FCC C2PC Request Letter

SUBJECT: Class II permissive change for FCC ID: 2AVMJX5P

XPLORA Technologies AS respectfully requests a class II permissive change for FCC ID: 2AVMJX5P, original grant date 07/27/2020.

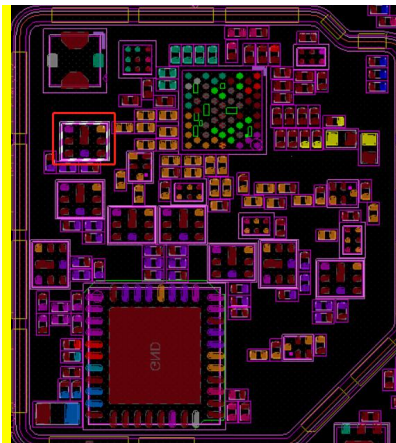
1. Turn off band12 and turn on band 20 through software and no rf parameters change.
2. No change of schematic and PCB Layout, just Replace the duplexer of band12 with the duplexer of band20, below mark red frame. no impact on EMC and SAR. (The FCC ID number: 2AVMJX5P is numebr change from FCC ID: 2AVMJX5PE, the FCC ID: 2AVMJX5PE is the original, so the FCC ID: 2AVMJX5PE Report as the C2PC original report.)
